[Docket No. 94-NM-28-AD; Amendment 39-9528; AD 95-13-12 R1]

Airworthiness Directives; Boeing Model 767 Series Airplanes Equipped With General Electric CF6-80C2 Series Engines

ACTION: Final rule; correction.

**Electro-Mechanical Brake and CDU Cone Brake Torque Check
Figure 1**

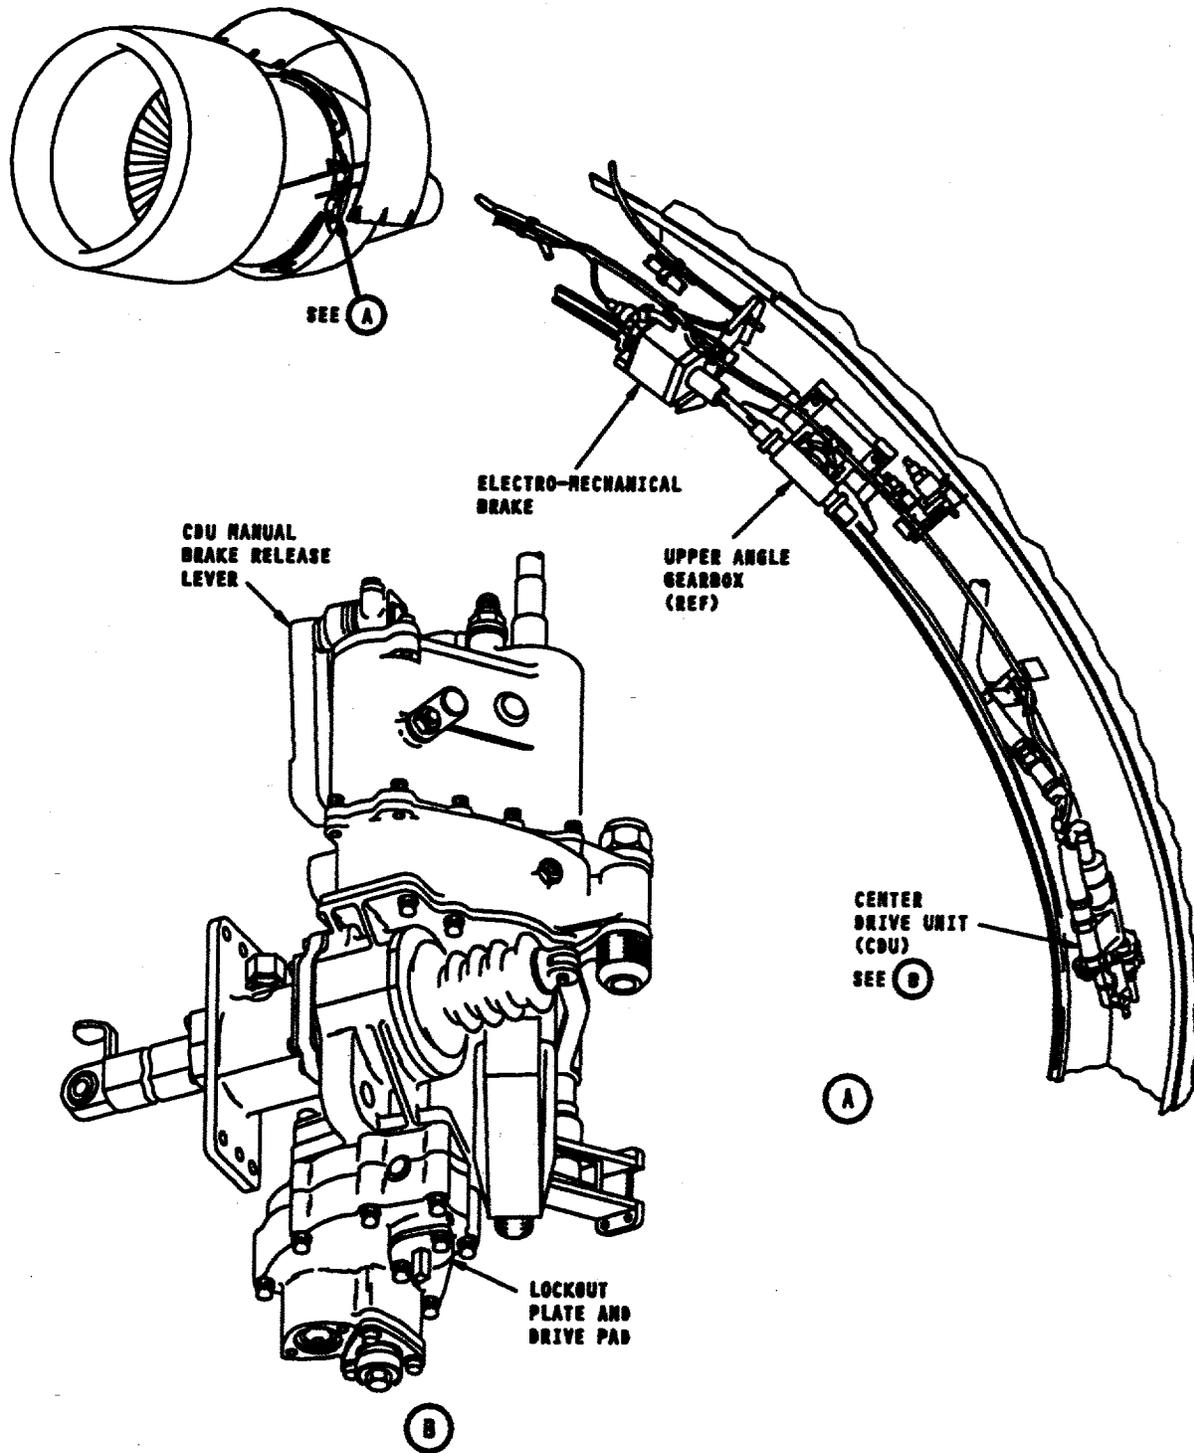
Since the issuance of that AD, the manufacturer has advised the FAA that a torque check value specified in Appendix 1 of the AD requires clarification. The procedures originally provided to the FAA for accomplishment of a torque check of the cone brake of the center drive unit (CDU) indicate that operators should not use more than 130 pound-inches of torque when performing the check. While using 130 pound-inches of torque would not damage the CDU, the manufacturer has advised the FAA that 100 pound-inches of torque is the appropriate value. Accomplishing the torque check up to 100 pound-inches is intended to identify a CDU having a decaying torque level due to a soft shaft problem, while at the same time not exposing the brake to unnecessarily high torque/stress levels.

2. Electro-Mechanical Brake and CDU Cone Brake Torque Check (Fig. 1)

Note: You will need a 24-inch extension to provide adequate clearance for the torque wrench.
 - (e) Apply 90 pound-inches of torque to the system.
 - (1) The electro-mechanical brake system is working correctly if the torque is reached before you turn the wrench 450 degrees (1 1/4 turns).

Caution: Do not use more than 100 pound-inches of torque when you do this check. Excessive torque will damage the CDU.

(6) Turn the torque wrench to try to manually extend the translating cowl until you get at least 15 pound-inches.

(a) If the torque is less than 15 pound-inches, you must replace the CDU.
